OTWAY WATER BOOK 43

Modelling Groundwater Impacts, Past, Present & Into the Future. (2018)

The aim of Otway Water Book 43 is to review some of the material presented in Jacobs' "*Barwon Downs Hydrological Studies 2016-2017, Groundwater Model Predictive Scenarios Report, 1 Draft, 18 December 2017, Barwon Water.*"⁽⁹⁾

Fig. 2 SOURCE: Jacobs

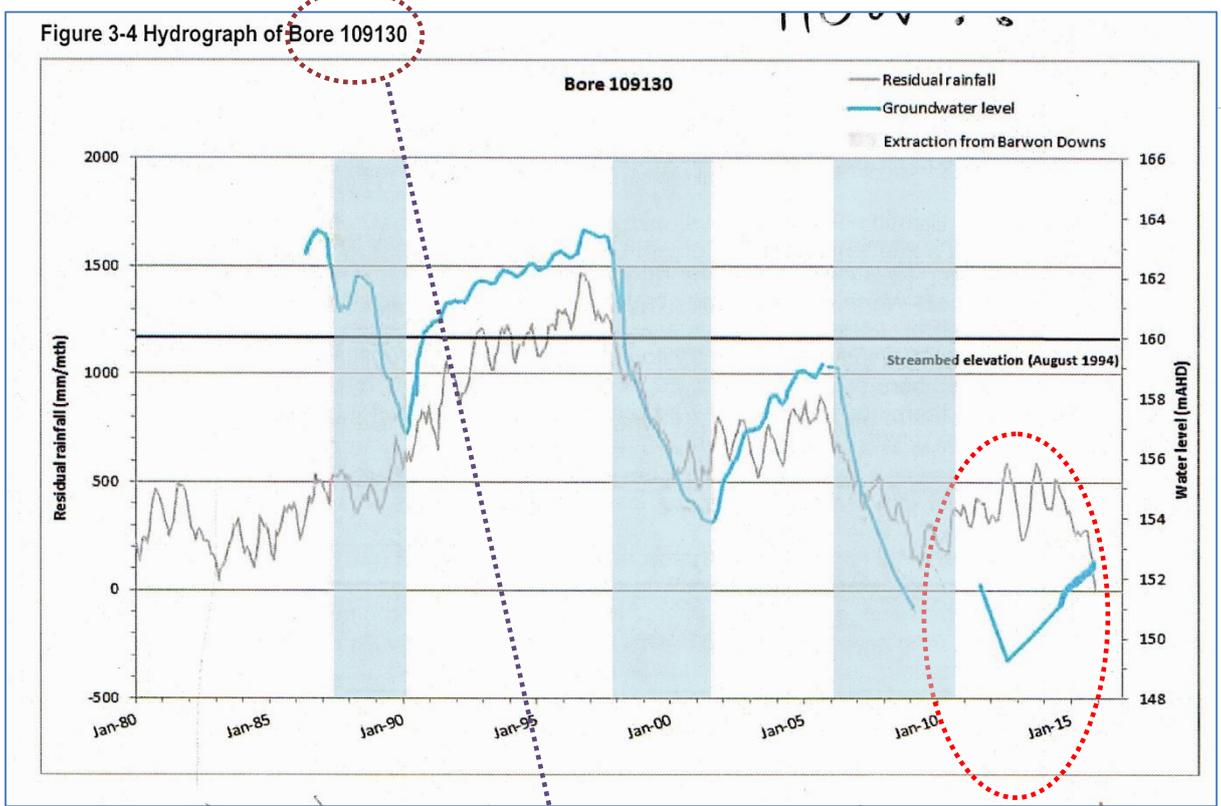
2. The figure reproduced below (see page 21) is found on page 36 of Jacobs’ 18 June 2017 report.⁽⁶⁾ The major extraction in 1982-83 does not appear on it. Neither is the source of the rainfall data stated. The 1982-83 drought extractions supposedly supplied 50% of Geelong’s water supply, making the 1982-83 extraction notable and should have been included on the hydrograph.

No explanation is given explaining what is happening where I have placed a dotted red oval around the last section of the figure. The hydrograph continued to drop quite severely taking some considerable time to start responding to the cessation of pumping and increased rainfall. This is markedly different and unlike the earlier behaviour as depicted in the graph. Rainfall and drawdown are not closely correlated.

Creek Catchment. The hydrographs shown in Figs. 2&3 for the same observation bore 109130 “paint” two very different stories. Fig. 3 depicts 109130 as almost flat.

Fig. 3 Otway Water Book 43.

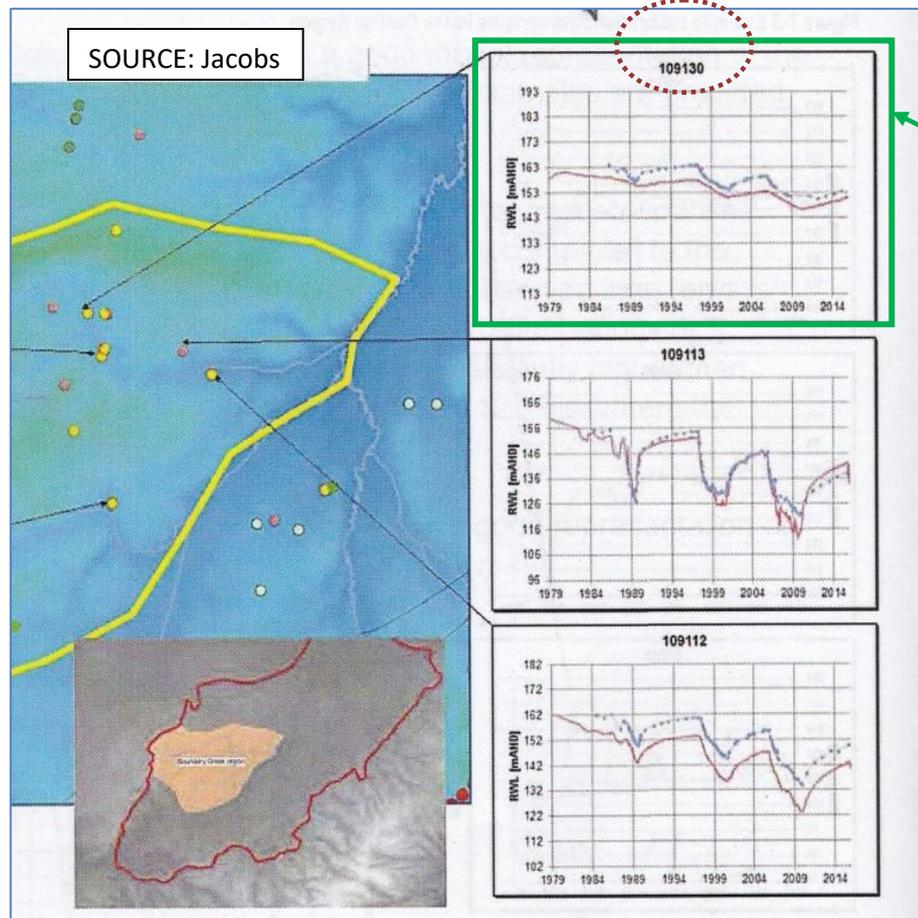
This part of a figure is copied from page 63 of the Jacobs' report⁽⁶⁾ depicting another way to view the rise and fall in observation bore 109130. This figure has been used as part of the explanation for what has been taking place in the Boundary

Fig. 4 Source. R. Evans presentation to Barwon Downs Groundwater Community Reference Group 2015.

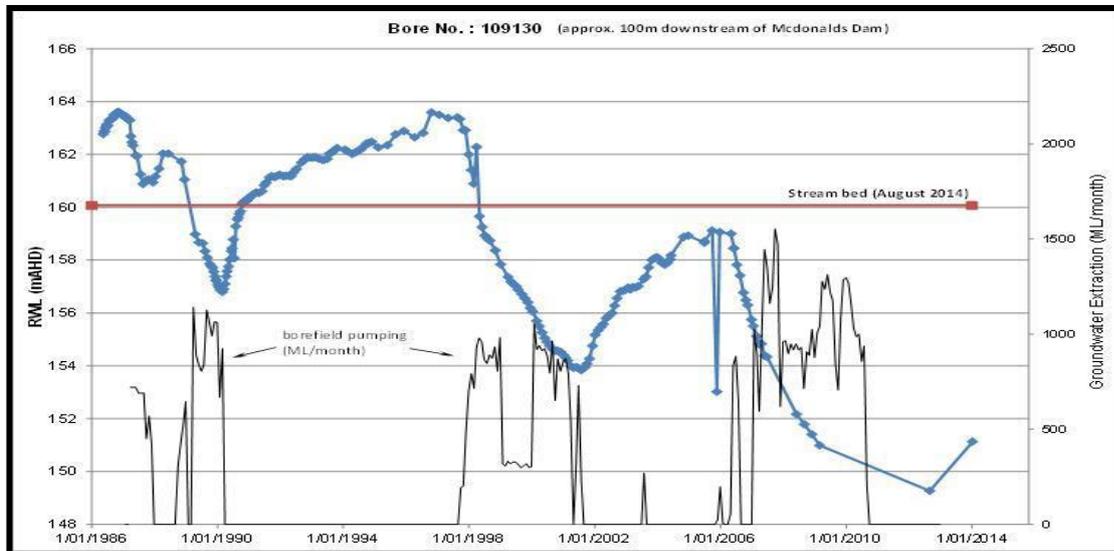
Fig. 4 is also a hydrograph of observation bore 109130 and includes the monthly extractions of groundwater. The extractions show a much better correlation in relation to the drawdown than the figure showing the relationship between drawdown and residual rainfall. The pumping causes the water tables to drop, whereas the rainfall lows simply indicate the reason why there was a need to conduct groundwater extractions.

Fig. 5

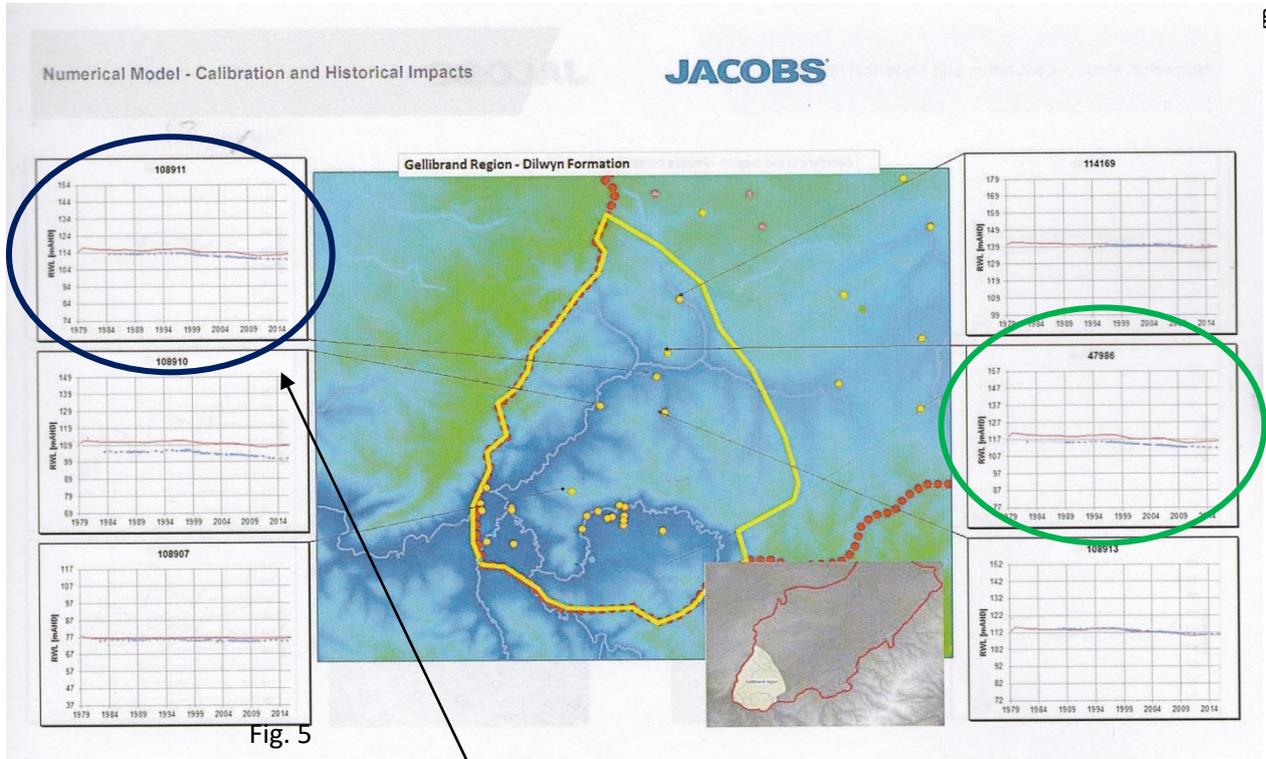
Scenarios Report⁽⁹⁾ December 2017, predicts that drawdown for Ten Mile Creek, Loves Creek and Yahoo Creek will be minor, and in the order of less than 0.1 m. The hydrographs in the **blue** and **green** circles certainly give this impression.

However, the hydrograph in the **blue circle** (observation bore 108911) looks markedly different to the one found for the same bore on the Southern Rural Water site.

The hydrograph in the **green circle** (observation bore 47986) is also markedly different to this same bore located on the Southern Rural Water web site.
